From: [S Mason](#)
To: [Rebecca Noecker](#)
Cc: [Spencer Miller-Johnson](#); [*CI-StPaul Contact-Council](#)
Subject: Public Comment in Opposition to Proposed EGAOD changes. Add a rear setback and step back to the EGAOD.
Date: Friday, July 19, 2024 1:06:09 PM
Attachments: [1- ANNOTATED Parritz public comment presentation.pdf](#)
[2-ANNOTATED Parritz public comment presentation.pdf](#)
[3-ANNOTATED Parritz public comment presentation.pdf](#)
[4-comments.pdf](#)
[5-Comments.pdf](#)

ANNOTATIONS TO PUBLIC COMMENT IMAGES

695 Grand Ave: Massing as constructed

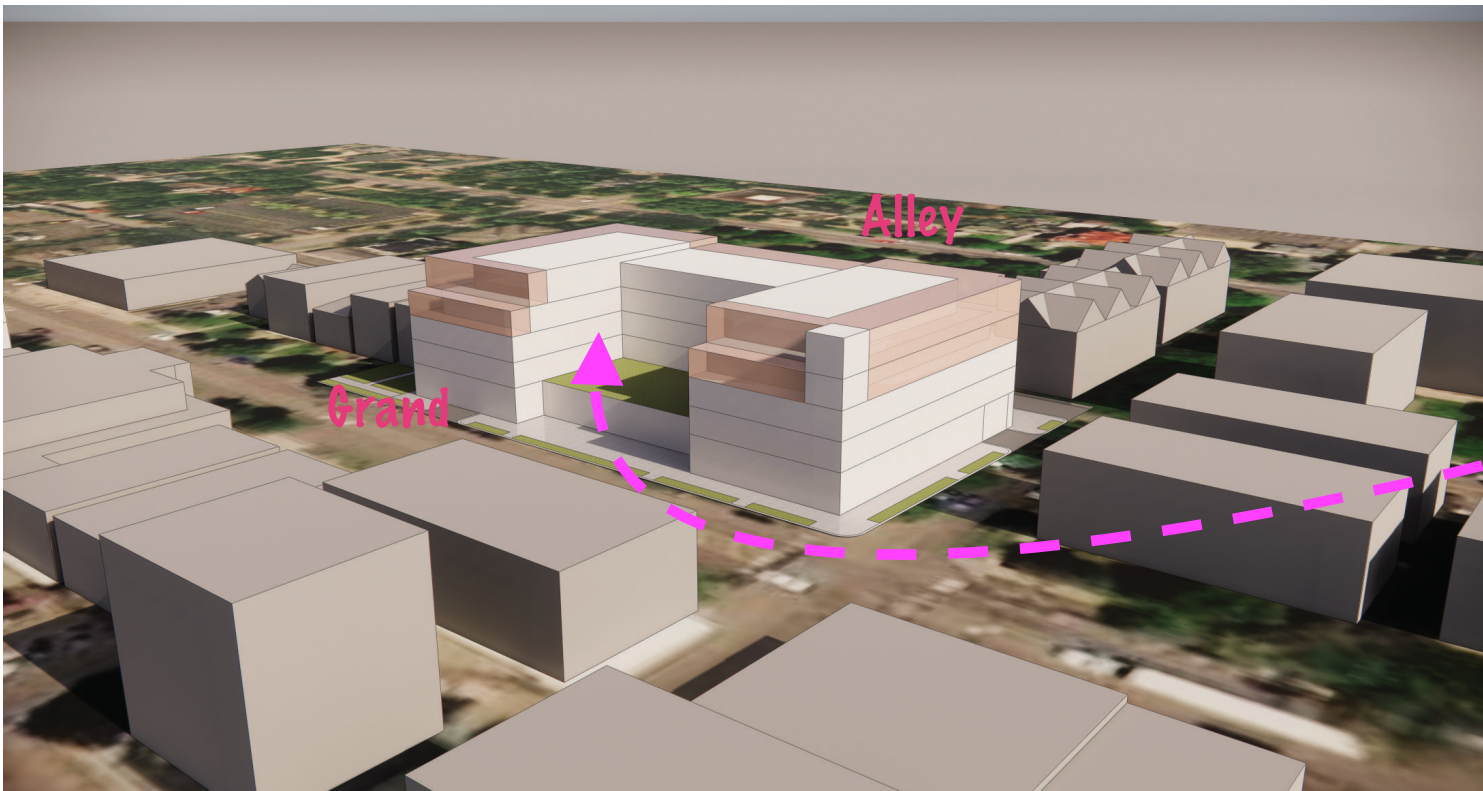
1 Why, in all of these, is there LESS bulk and building mass facing Grand?

And MORE bulk close the neighbors?

Why is there a giant area on Grand that could be built, but wasn't?

Why is it NOT built?

695 Grand Ave: Possible Massing

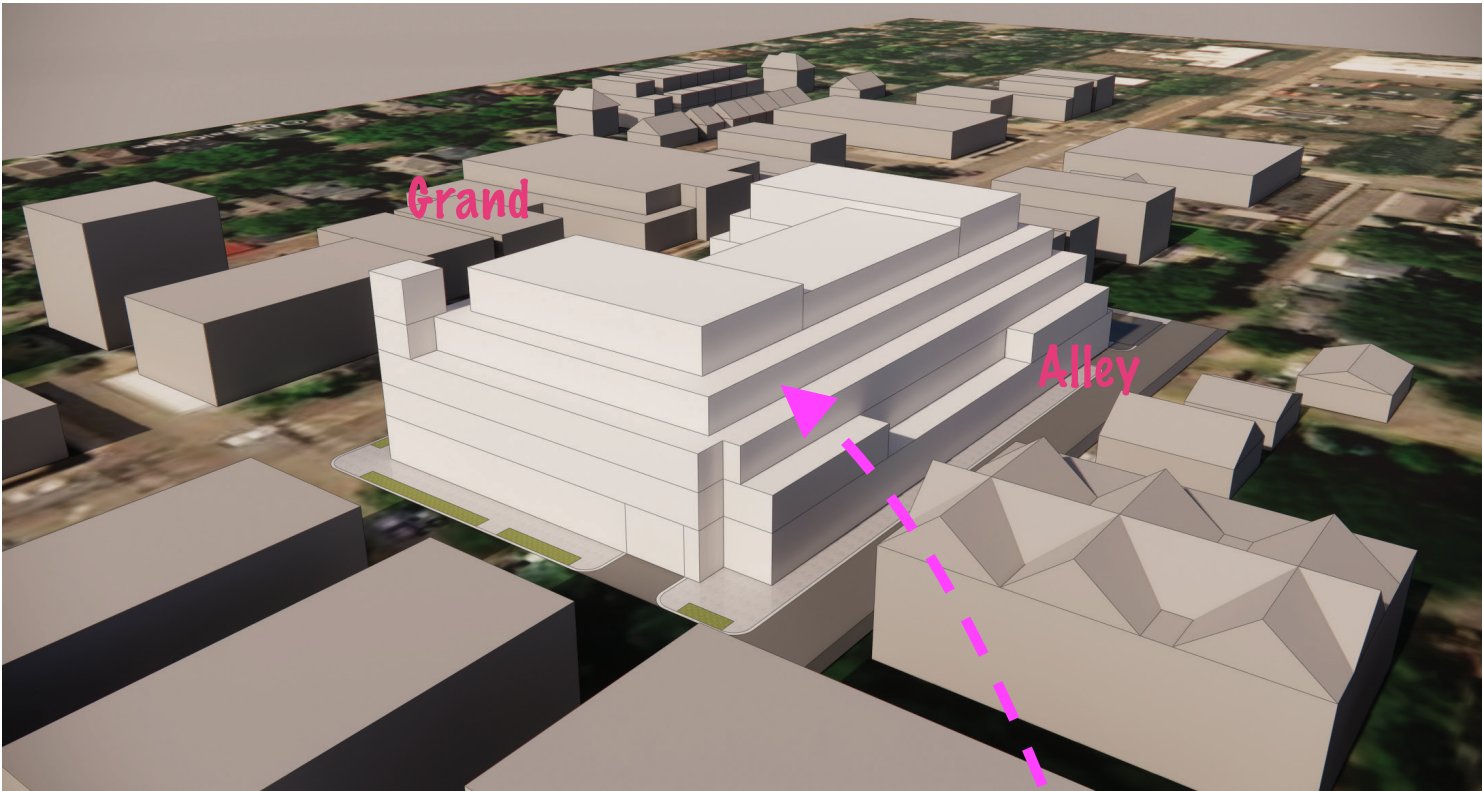
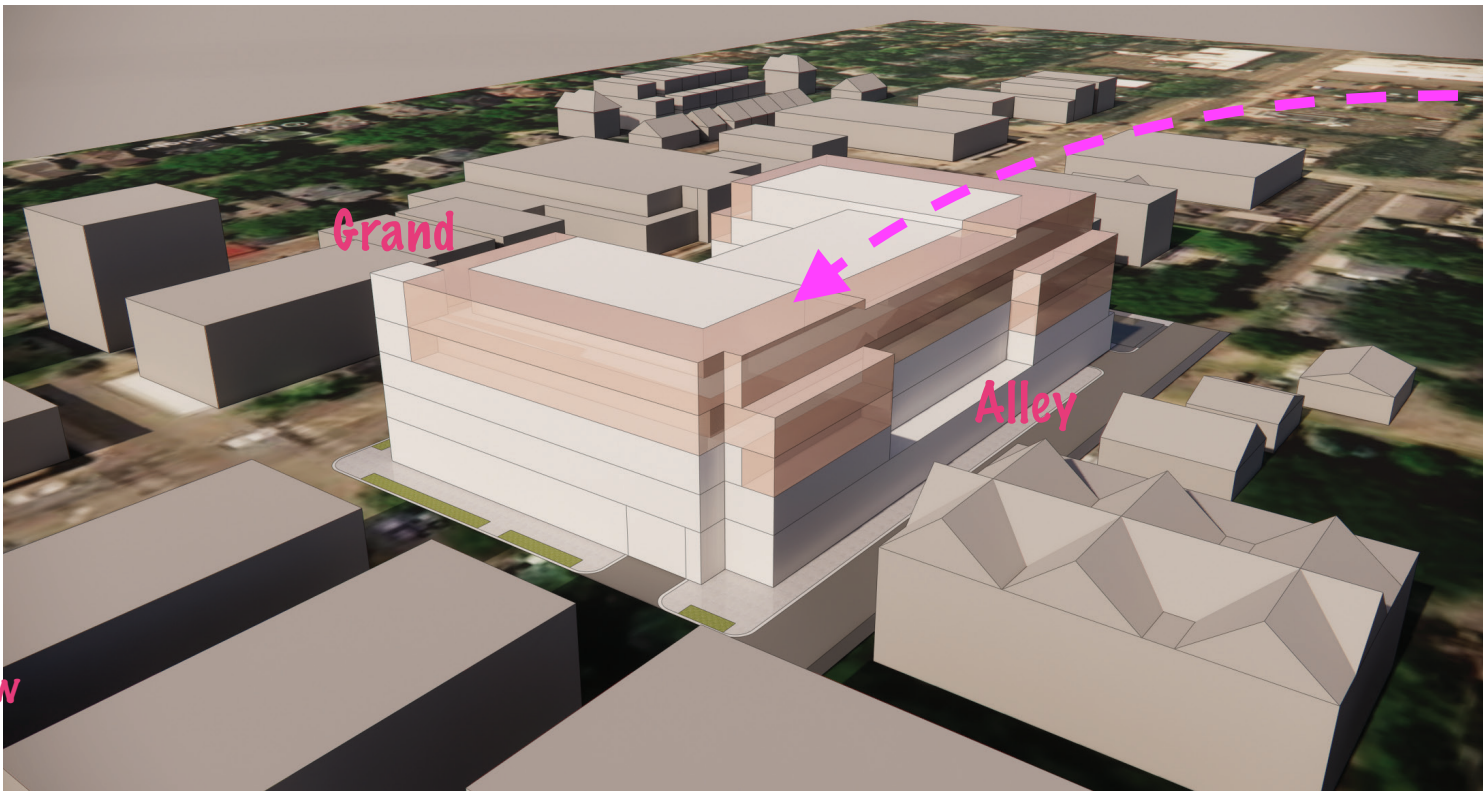
Imagine this flipped.
Why is there more height
and more massing
at the rear,
toward the residential
neighborhood?

Residential neighbors near 695 Grand
have been negatively impacted by the
tall walls that were constructed:

- * ice build up in the 6-month fully shadowed alley has impeded access & trash collection
- * a 90 dBA piece of equipment installed in the narrow strip of land along hte alley runs 24-7 in the summer, limiting neighbors ability to use outdoor spaces and have open windows.
- * Litter (chiefly cigarette butts & dog poop) is a huge problem as the building has no outdoor space for employee smoking or dog relief.

This would be somewhat better.

Removing the highlighted
areas would be an improvement
for residential neighbors to the north.
However, there is still too much
building oriented toward low density.

Why is the building oriented
away from Grand?

Since Grand needs development, then the building and its bulk, as well as its noise, deliveries and activity should all be oriented toward Grand

These "POSSIBLE MASSINGS" are better than what was built at 695 Grand.
The lower images show better "transitions" to sensitive areas, to the housing & neighbors NOT on Grand

734 Grand Ave: Possible Massing

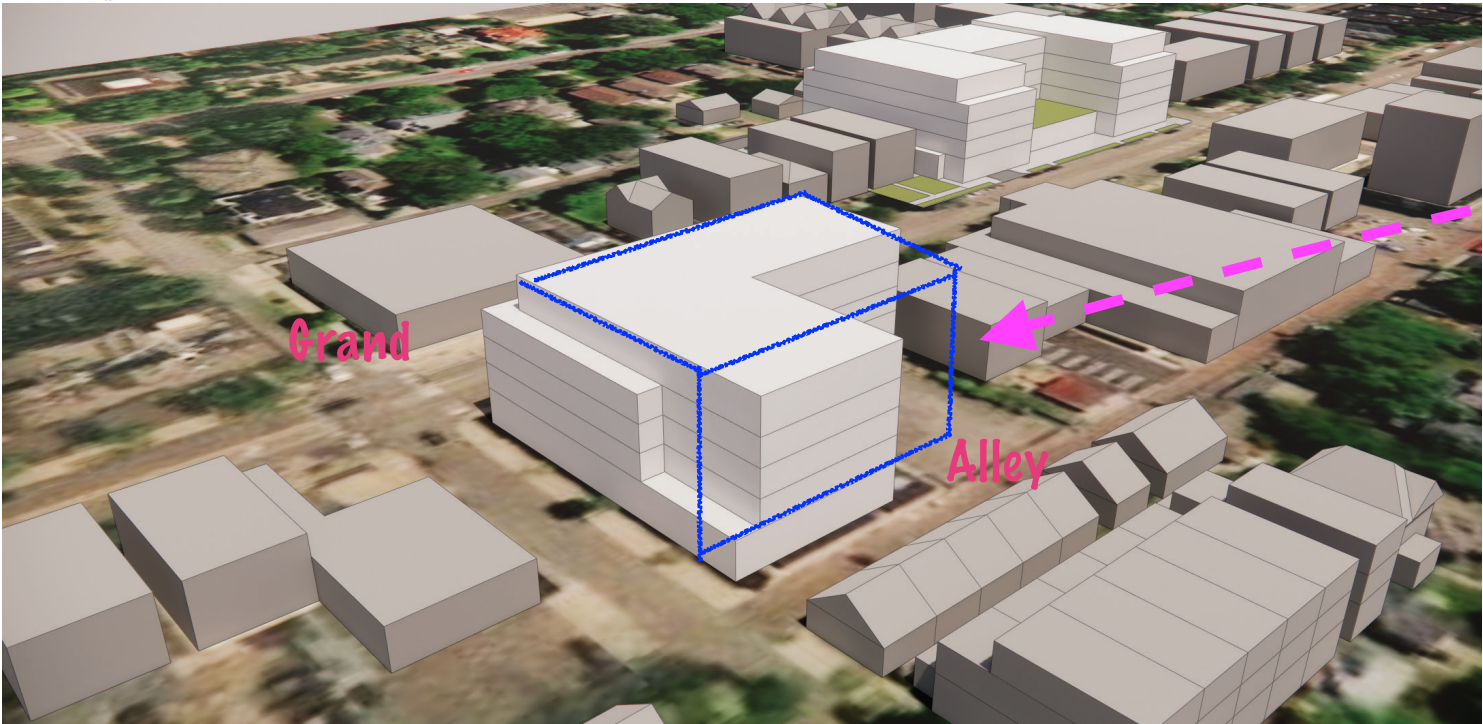
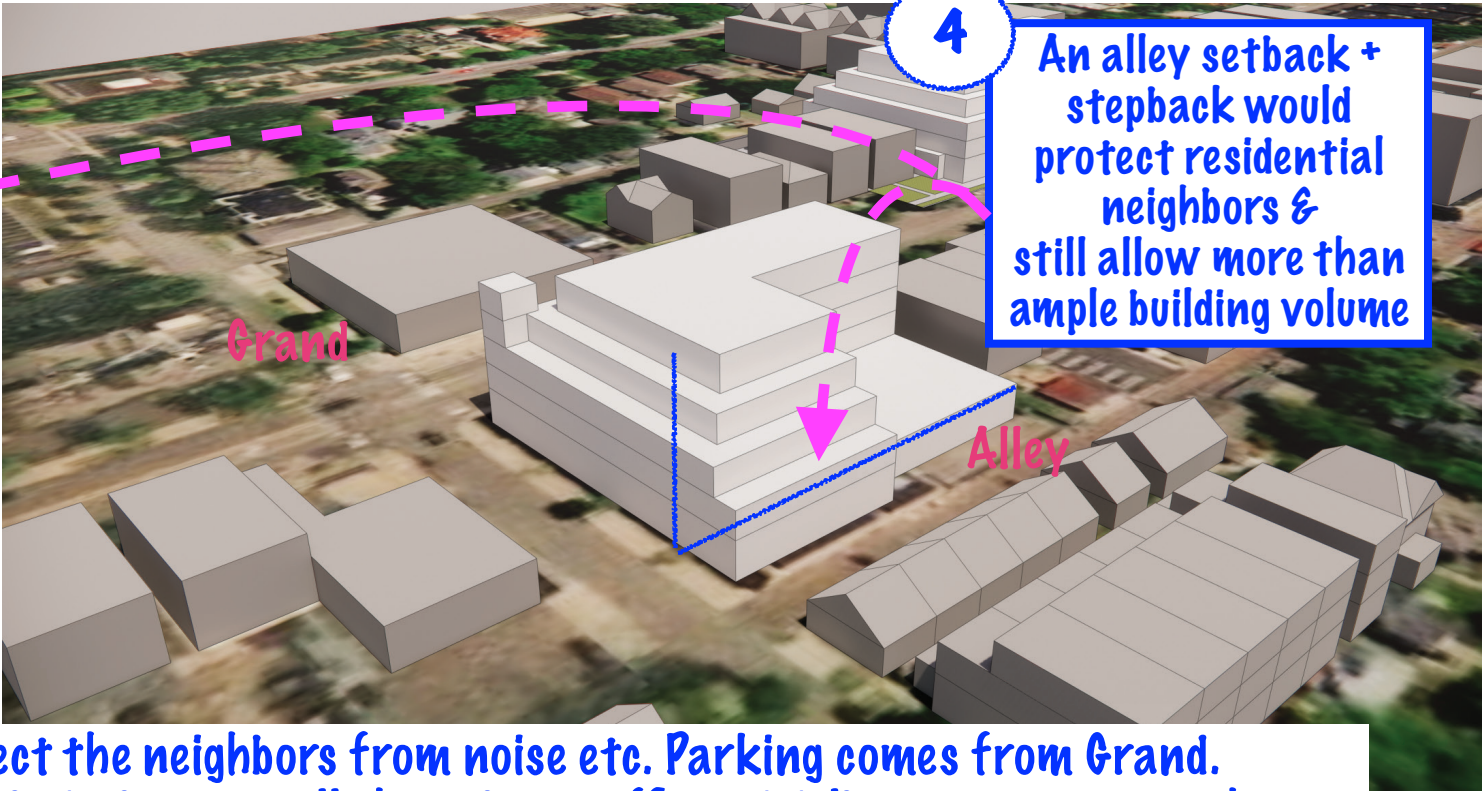
But why does the Tall Height and Large Bulk need to come all the way back to the alley?
Why not provide a buffer space to protect the residents on Lincoln from the noise, loss of privacy, etc.

This is the Walgreens sight. They currently have a tall fence to protect the neighbors from noise etc. Parking comes from Grand. Deliveries happen from Grand & Grotto. The alley is a quiet buffer, This design puts all the noise, traffic and delivery pressure on the residential alley. There is no place for moving trucks and deliveries for the (presumed) 80+ luxury apartments. This layout would likely have noisy equipment installed right at the alley, close to neighbors. This design reduces privacy & provides no buffer.

The Overlay must provide protections for the neighbors on Lincoln, Summit, & side streets.

An alley setback + stepback would protect residential neighbors & still allow more than ample building volume

Here is an image of 695 Grand as built, with December Shadows.

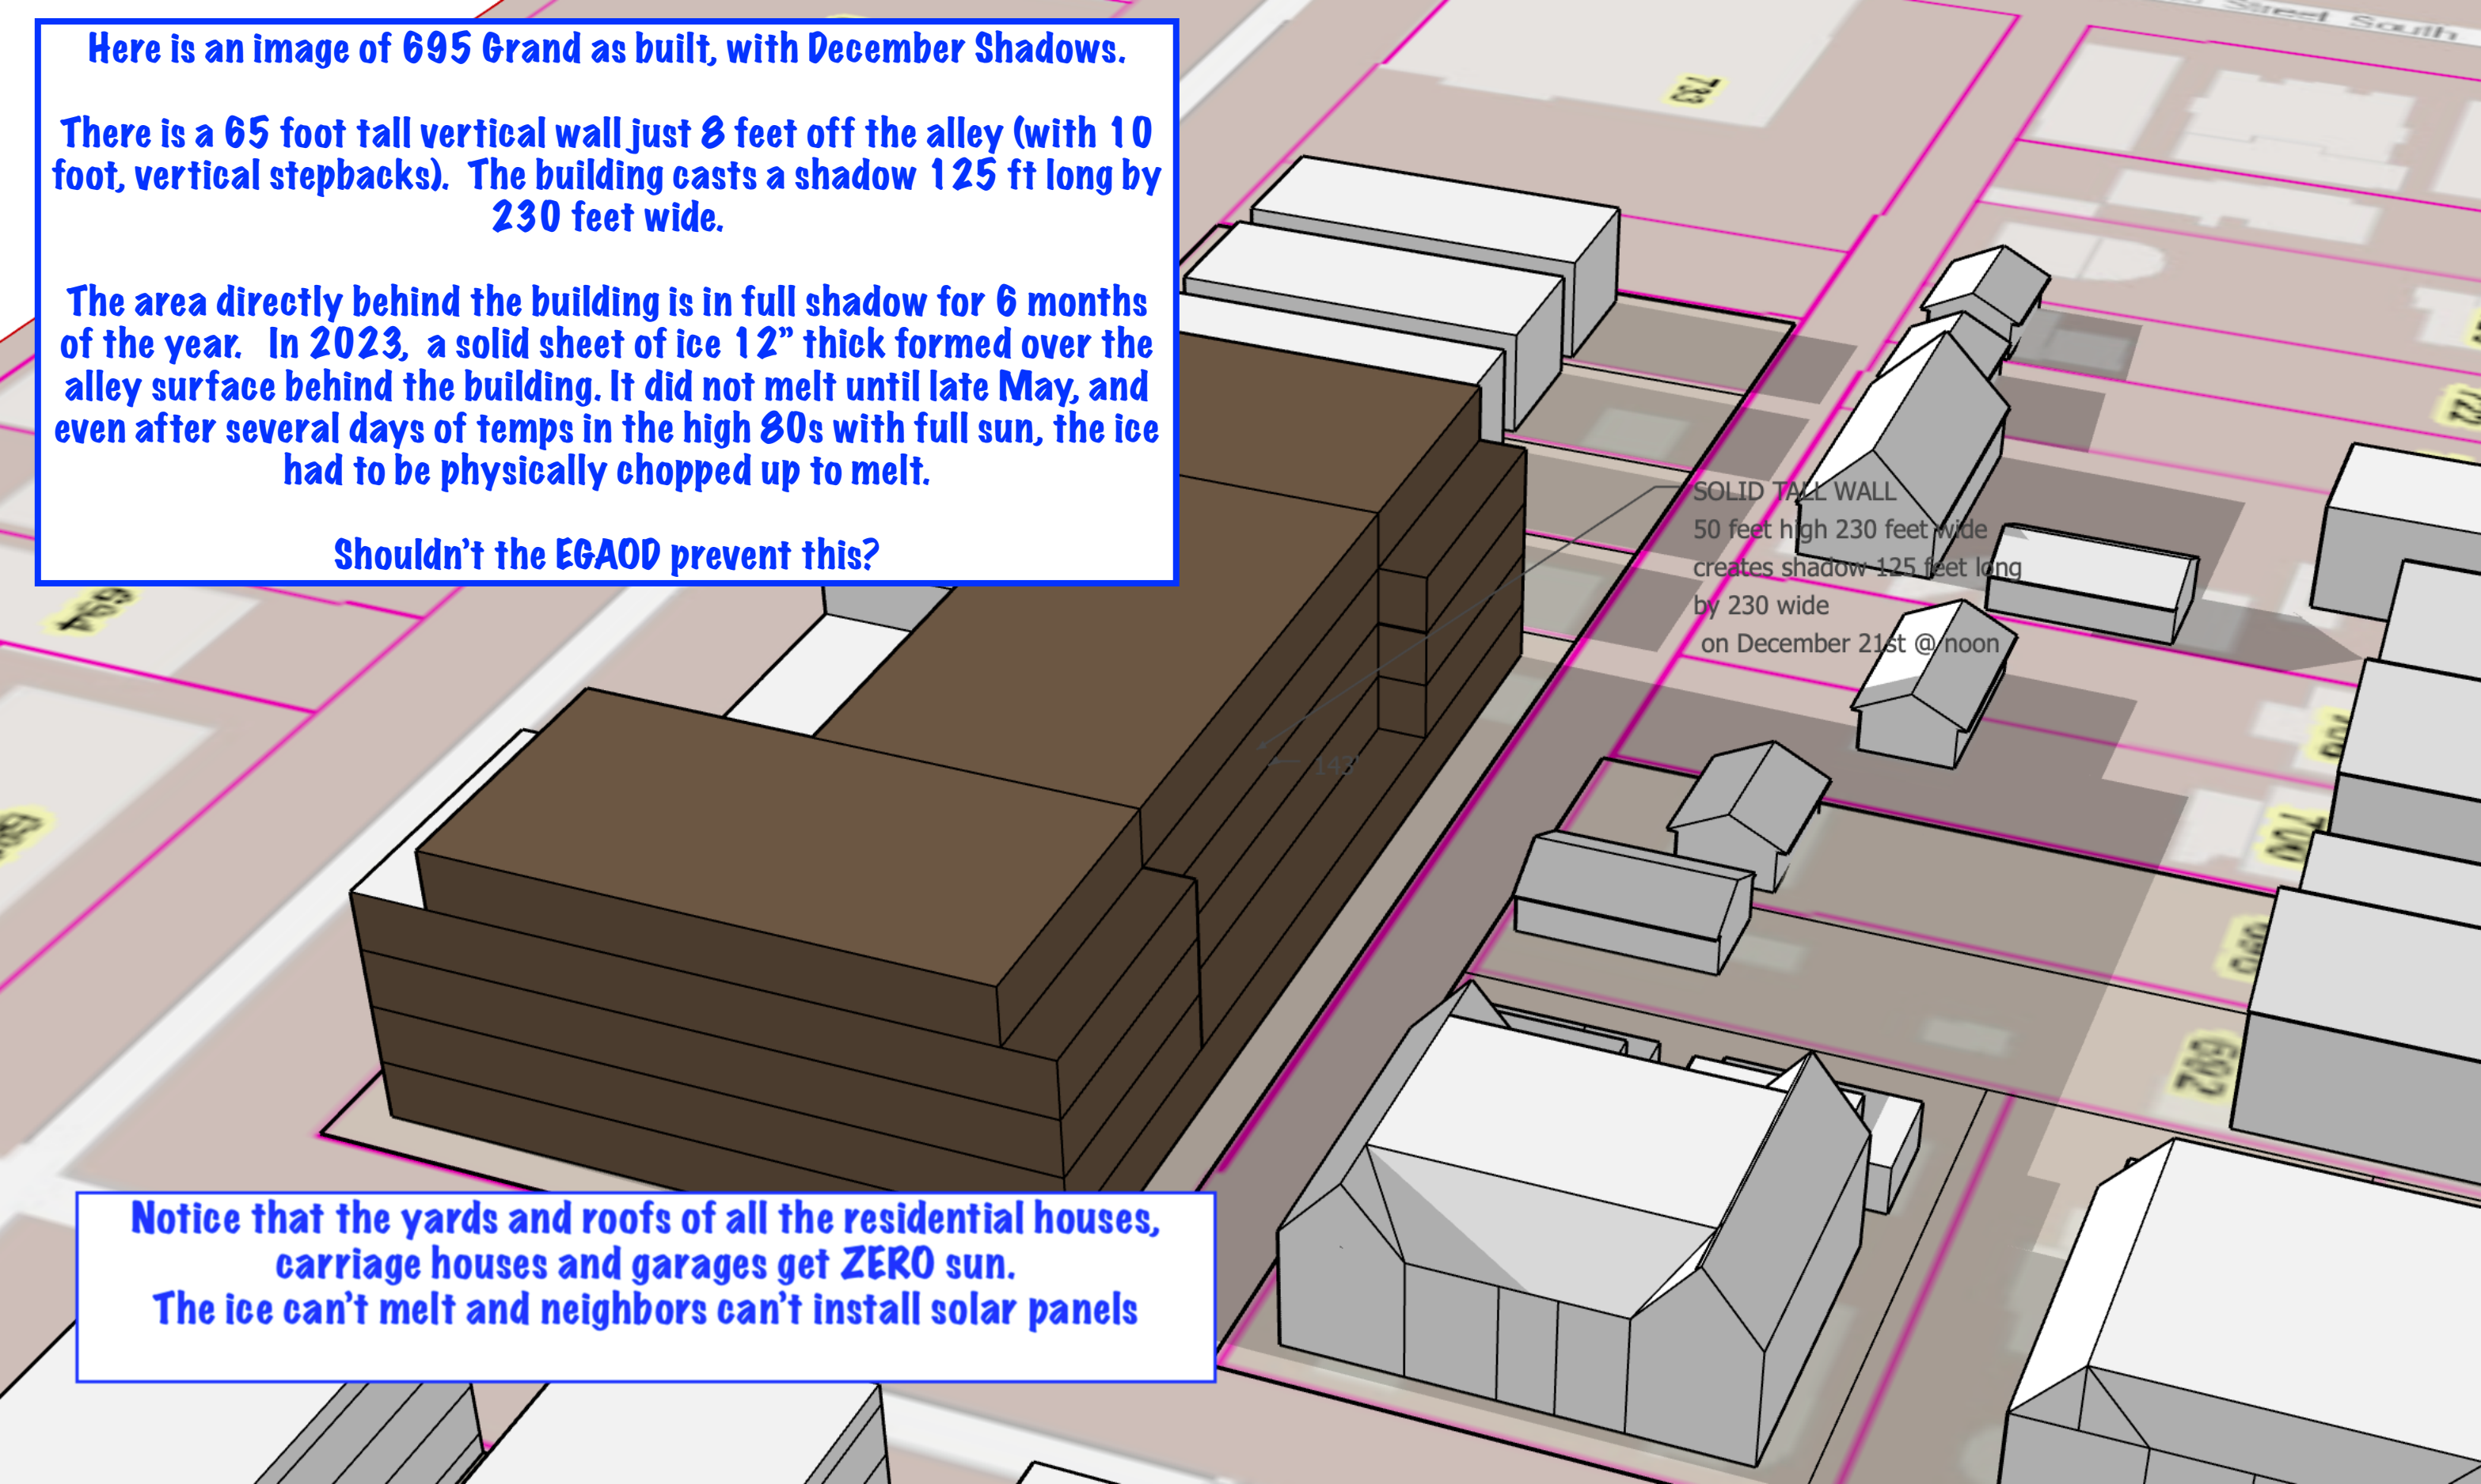
There is a 65 foot tall vertical wall just 8 feet off the alley (with 10 foot, vertical stepbacks). The building casts a shadow 125 ft long by 230 feet wide.

The area directly behind the building is in full shadow for 6 months of the year. In 2023, a solid sheet of ice 12" thick formed over the alley surface behind the building. It did not melt until late May, and even after several days of temps in the high 80s with full sun, the ice had to be physically chopped up to melt.

Shouldn't the EGAOD prevent this?

SOLID TALL WALL
50 feet high 230 feet wide
creates shadow 125 feet long
by 230 wide
on December 21st @ noon

Notice that the yards and roofs of all the residential houses, carriage houses and garages get ZERO sun.
The ice can't melt and neighbors can't install solar panels
